Refer to: HNG-14/SS-79

This is in response to your March 2 letter to the Director of the Office of Engineering, Federal Highway Administration (FHWA) requesting acceptance of HwyCom fiberglass posts mounted in an anchor bolted to the pavement. These posts, mounted in a "Universal Anchor System" (UAS) foundation, were found acceptable in our April 9, 1997, letter to Mr. Donnie L. Reagan of Universal Anchor Systems when mounted in "standard" soil. The analysis by Mr. Roger P Bligh of Texas Transportation Institute that accompanied your letter indicates that HwyCom posts mounted in the proposed bolted anchor would perform at least as well as they did in the full-depth anchors when they were crash tested. We have reviewed that analysis, the drawings of the proposed bolt down base (copies enclosed), and the report of the crash testing, and concur in Mr. Bligh's analysis.

Geometric and Safety Design Acceptance Letter SS-79

BOLT DOWN UNIVERSAL ANCHOR SIGN SUPPORT

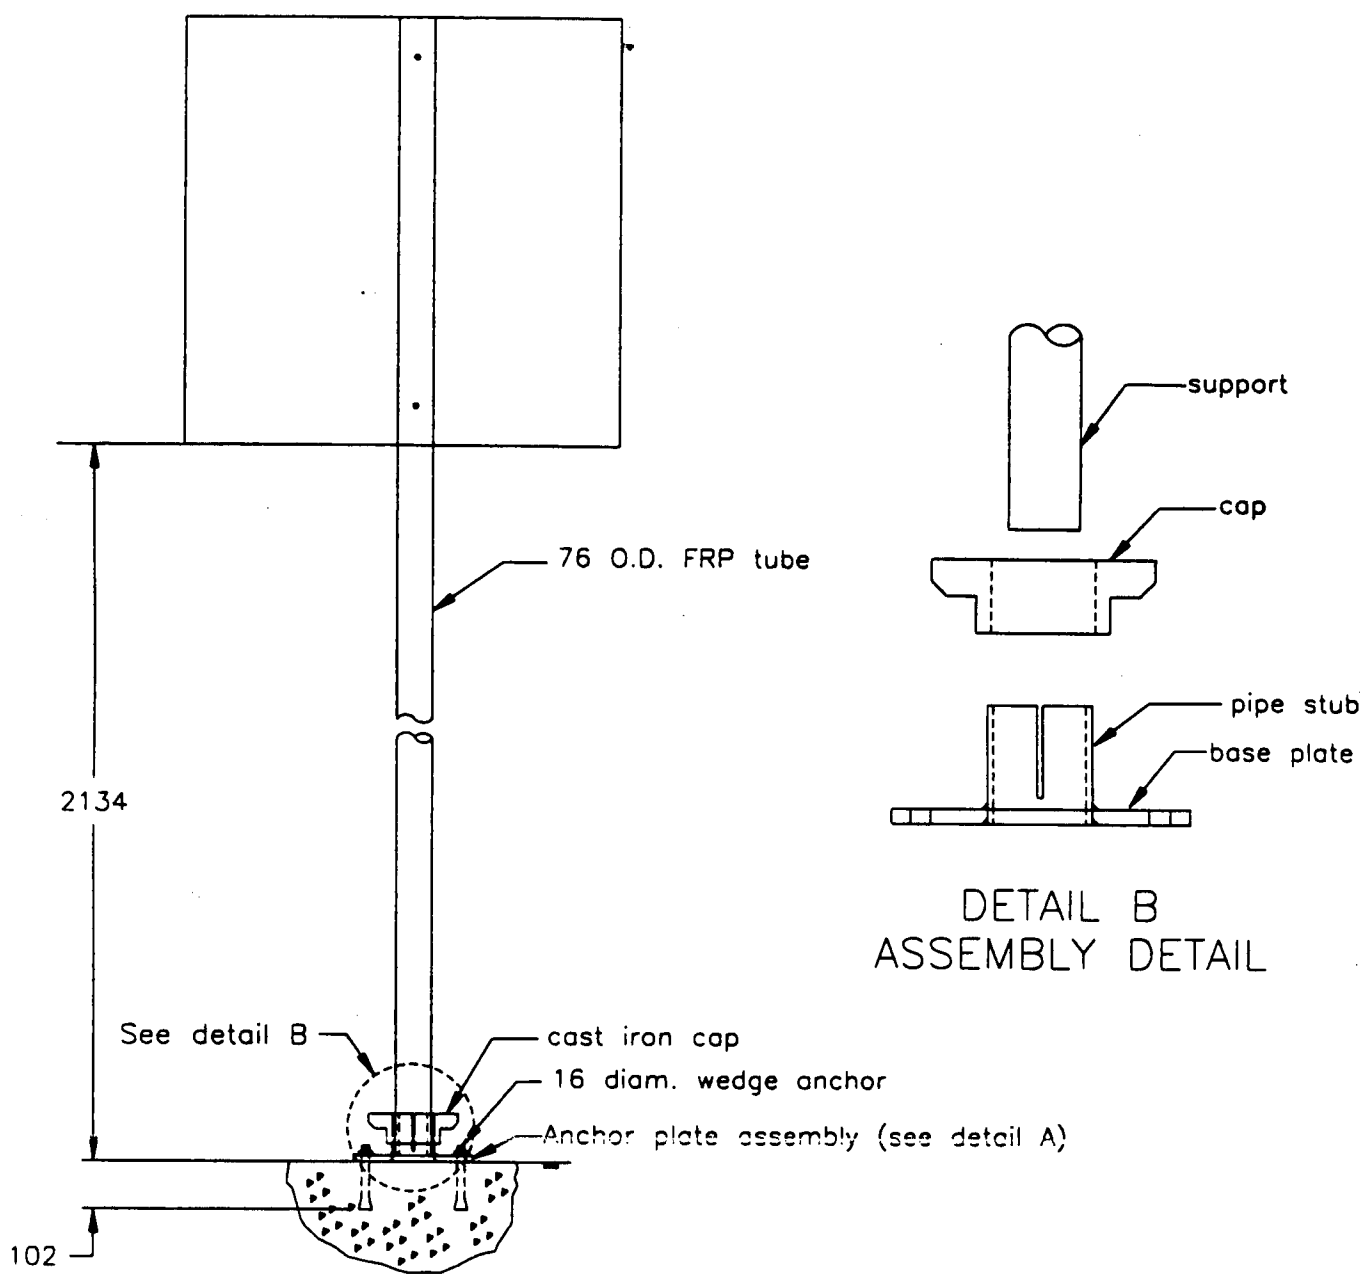
Therefore, 76-mm OD, 3.175-mm (1/8-inch) wall fiberglass reinforced plastic tube sign supports mounted in the 100-mm high Universal Anchor System Bolt-Down Base are acceptable for use on the National Highway System (NHS) when requested by a State under the following conditions:

1. Single post installations have a maximum sign area of 1.49 square meters (16 square feet).
2. Dual post installations have a maximum sign area of 2.97 square meters (32 square feet).
3. Sign attachment hardware and location of attachment hardware will be as recommended in the TTI Report dated December 1996 and repeated in our April 9, 1997 letter reference above (Acceptance Letter SS-75).
4. Each anchor bolt will be a minimum of 15.875 mm (5/8 inch) in diameter, be embedded a minimum of 100 mm (4 inches) plus one bolt diameter, and have a rated pullout capacity of 54,666 N (12, 300 pound) or greater.
